Flight Procedures Cover Page	Task Action: FLIGHT CHECK	Task Type: STAR	Estimated Chart Date: 12/02/2021	APWS Task ID: ACB4F7831B3C41948BAAD823CF8906BC	APWS Project ID: B4AF77E855054F7985AA724411950675
Procedure: PALMZ TWO STAR		Enroute: YES	Specialist: Harris, Michael		Agreement Number:
Airport ID: KMIA		Airport City: MIAMI		State: FL	
Facility ID:	Facility Type:	Flight Inspection Remark Type: New FC Slot			
<p>Procedure Comments: FL METROPLEX ADD FIX DUMDY WITH HOLDING TO RSW TRANSITION. POST- IMPLEMENTATION; NO NEW LOA REQUIRED, EXISTING (INFO ONLY) INSERTED INTO S FILE. ACTIVE AIRNAV DATA USED.</p> <p>CONTACT ALLAN WILL- AJV-A423 405.954.6103</p>

FIPC BASIC FORM							
PROCEDURE: PALMZ TWO STAR			AIRPORT NAME: MIAMI INTL		AIRPORT ID: KMIA	SPECIAL CONTROL NO: AP-08-150-21	
FAC ID: PALMZ2		CITY: MIAMI			ST: FL	ORIG CHART DATE: 12/02/2021	
DFL TYPE: PROC/T	THIRD PARTY: <input type="checkbox"/> YES	EST. TIME ON SITE: 0.4	REIMB. NUMBER:		PTS TASK ID:		
PREFLIGHT NOTES							
REVIEWER:					DATE:		
COMMENTS:					CHECK ONE:		
					<input type="checkbox"/> FLT CK REQ <input type="checkbox"/> NFCR <input type="checkbox"/> REJECT		
							YES
					CPV COMPLETE?		X
PROCEDURE RESULTS

Arrival Name	Number	STAR Computer Code	Superseded Number	Dated	Effective Date
PALMZ TWO	TWO	PALMZ.PALMZ2	PALMZ ONE	22 APRIL 2021	
Graphic Depiction 1

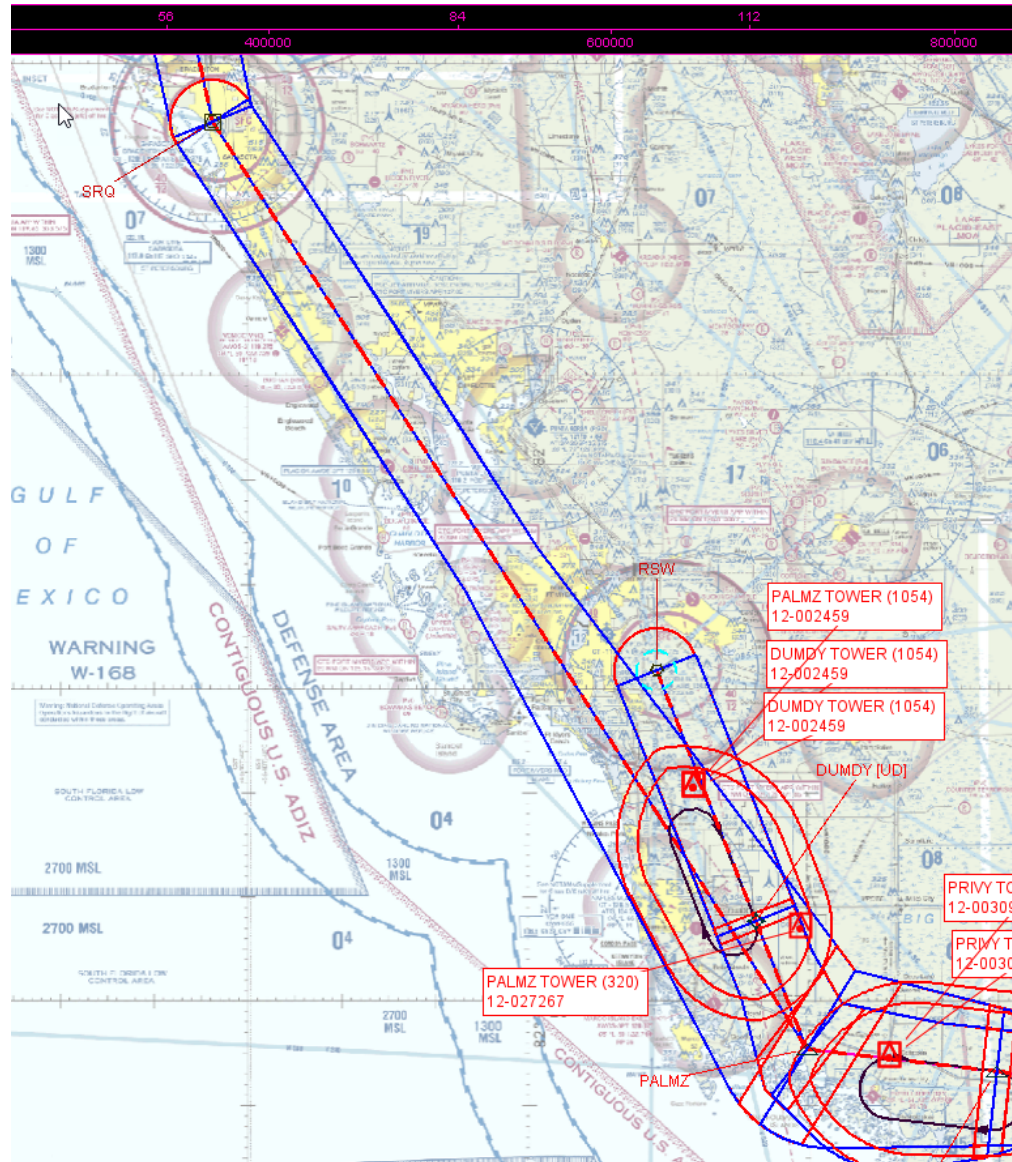
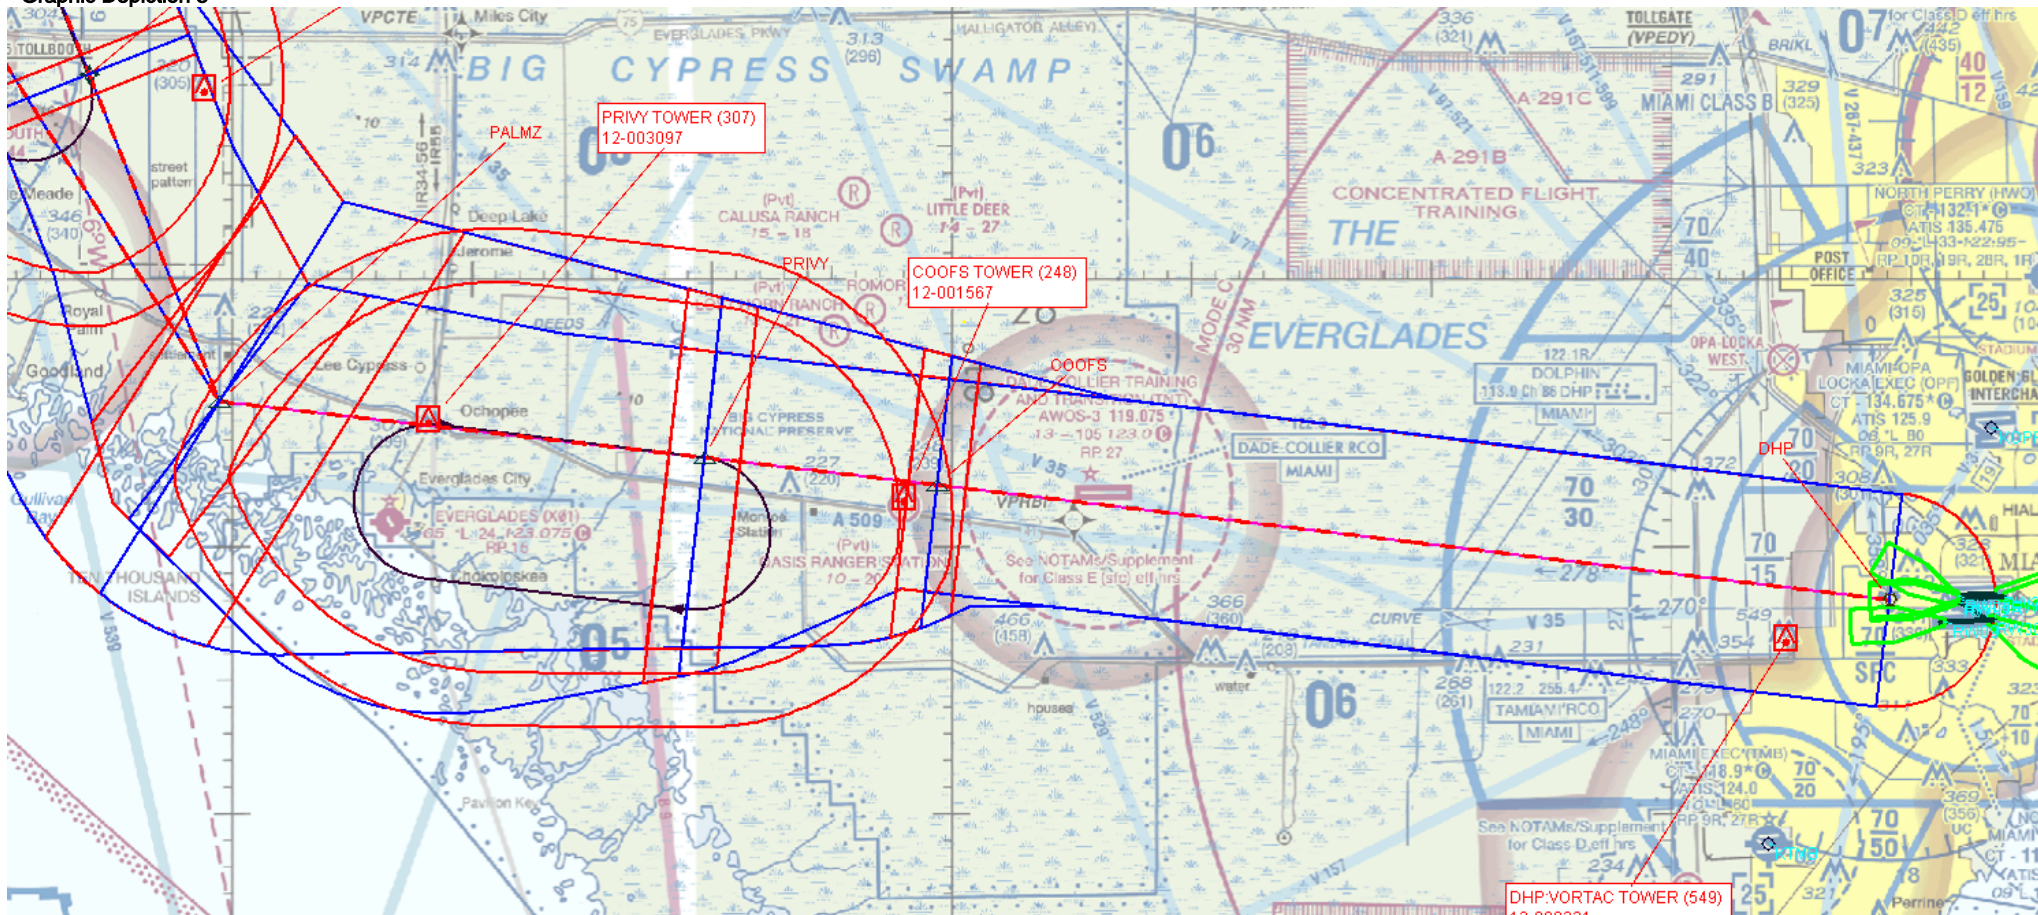
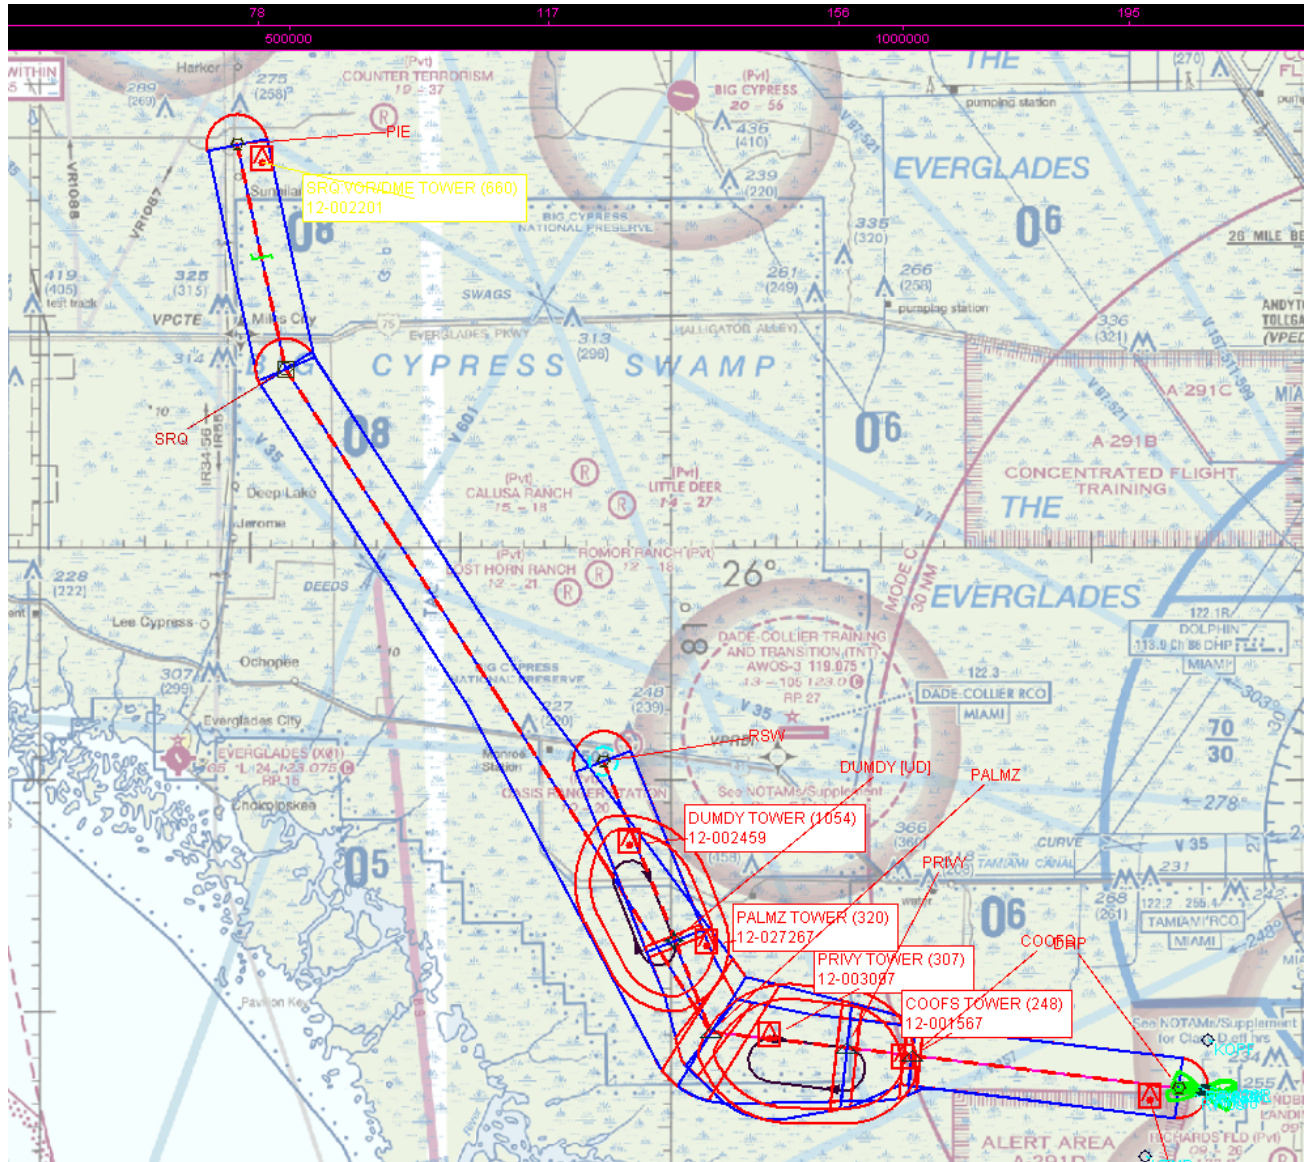
FLIGHT INSPECTOR REMARKS: Added fix DUMDY with holding pattern to RSW transition. Part of FL METROPLEX Miami INTL, Miami, L, PALMZ TWO ARRIVAL							
IN-FLIGHT OBSTACLE REPORT							
OBSTRUCTION ID #:	COORDINATES OR LOCATION:		GNSS ALTITUDE (MSL):		BAROMETRIC ALTITUDE (MSL):		HEIGHT ABOVE GROUND LEVEL:

8260.3, 2-2-7d(4) Do not raise an MEA to support ATC operational requirements. An altitude restriction must be used if ATC has an operational requirement for an altitude higher than the MEA.

Due to an oversight a higher MEA was published based on ATC request and a lower MEA is available. This was not discovered in a timely manner to fix. This waiver is being submitted as a temporary solution until the next update of the procedure. Timelines do not allow this to be fixed before publication.

- 1) The altitude used provides obstacle clearance, communications and NAVAID reception. These altitudes have also been flight inspected. A MOCA is also part of the procedure.
- 2) RADAR Required is part of the procedure so ATC can intervene if a pilot needs a lower altitude.
- 3) These procedures will be amended by the Service Center, with the VORMON program scheduled in be completed Dec 25.
